REMARKS

Serial No. 10/647,468
Docket No. 2002-249352US

FIG. 1

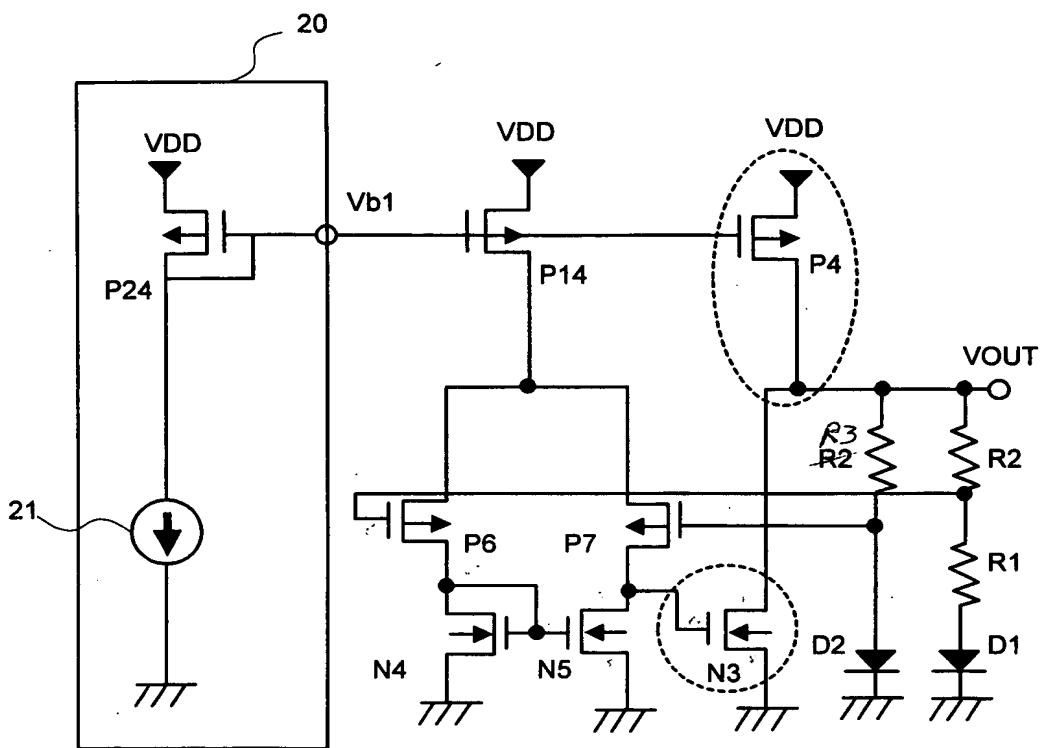
The Office Action objects to the drawings due to duplicated reference characters in Figures 1, 2, and 10. Corrected drawings are submitted herewith. Corresponding amendments have been made to the specification.

In Figure 1, the left-most reference character R2 is changed to R3.

FIG. 2

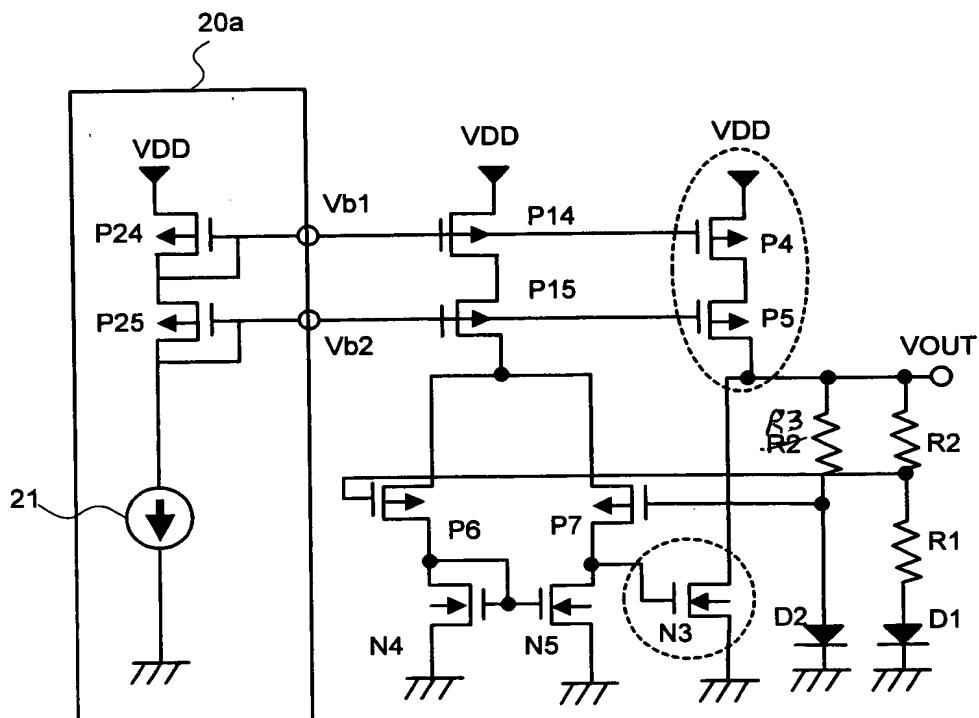
In Figure 2, the left-most reference character R2 is changed to R3.

FIG. 8
PRIOR ART

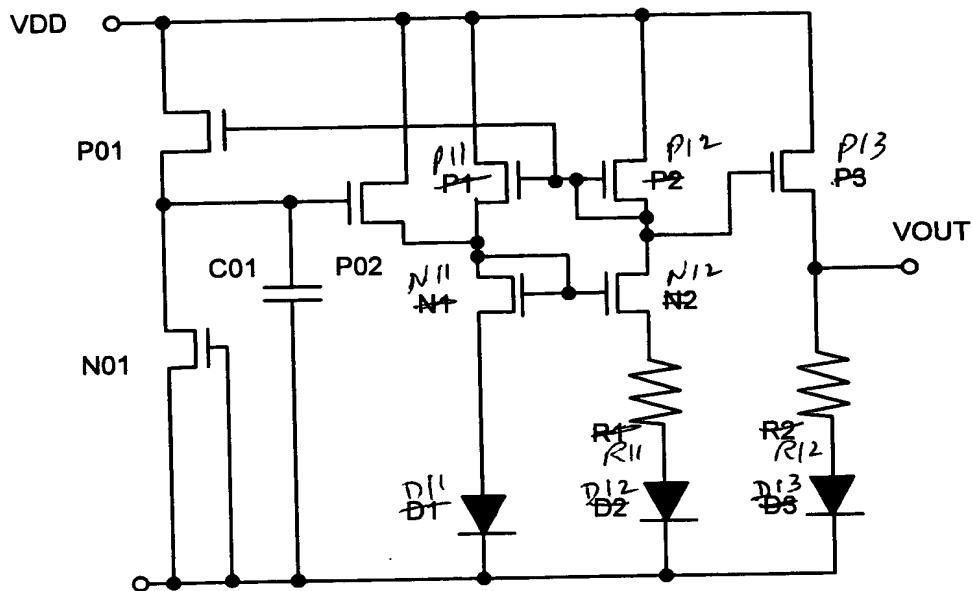
In Figure 8, reference character P1 is changed to P11, reference character P2 is changed to P12, reference character P3 is changed to P13, reference character N1 is changed to N11, reference character N2 is changed to N12, reference character R1 is changed to R11, reference character R2 is changed to R12, reference character D1 is changed to D11, reference character D2 is changed to D12, and reference character D3 is changed to D13.

FIG. 10
PRIOR ART

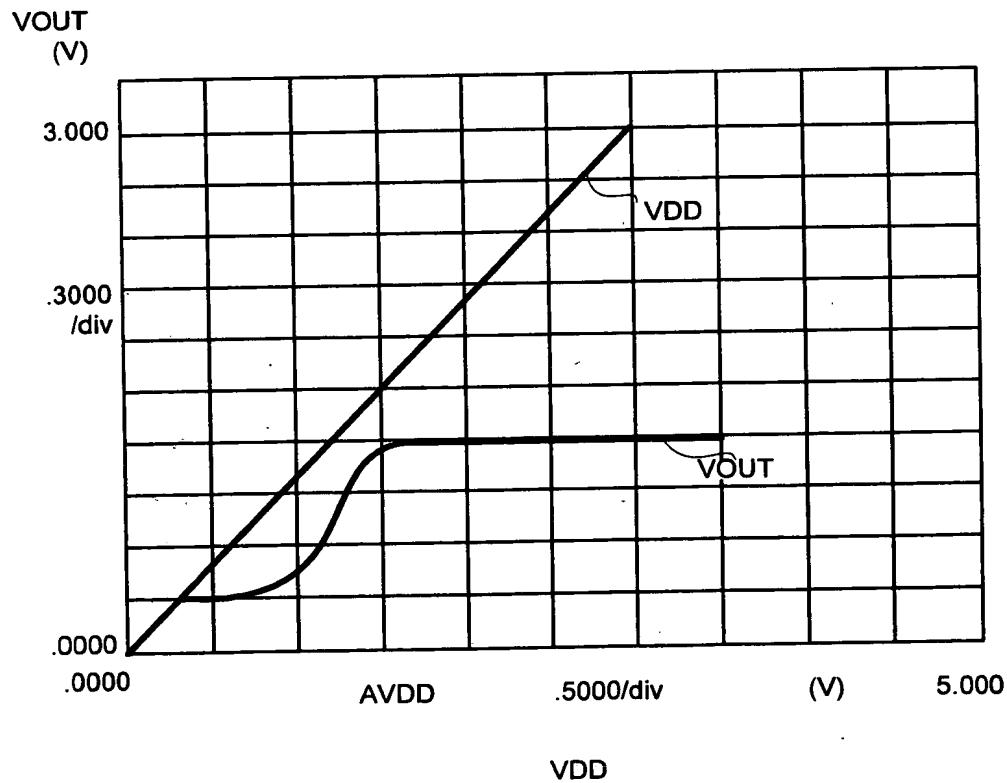
In Figure 10, the left-most reference character R2 is changed to R3.
